DART SERVICE INSTRUCTION

TO AMEND INSTALLATION DRAWING D204-618 REV. B

(REF. CANADIAN STC: SH91-40, FAA STC: SR00505NY)

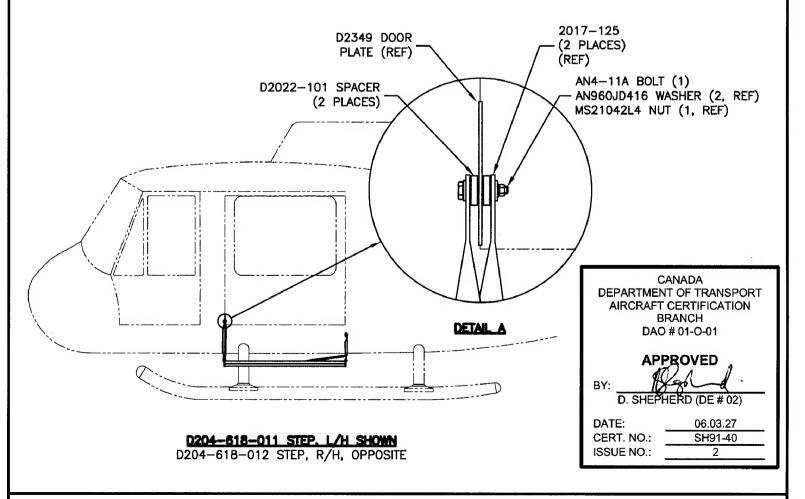
FOR INSTALLATION OF D204-618-011/-012, IT IS NECESSARY TO ADD (2) D2022-101 SPACERS PER KIT TO INSTALL THE STEP. CONSEQUENTLY, LONGER BOLTS ARE NEEDED AS PER DETAIL A BELOW TO ALLOW THE INSTALLATION OF THE SPACERS. THIS CHANGE IS REQUIRED BECAUSE THE TUBE SECTION OF THE STRUTS INTERFERE WITH EACH OTHER BEFORE THE TABS CONTACT THE DOOR PLATE BRACKET.

REPLACE: QTY (1) AN4-5A BOLT WITH: QTY (1) AN4-11A BOLT

ADD: QTY (2) D2022-101 SPACERS
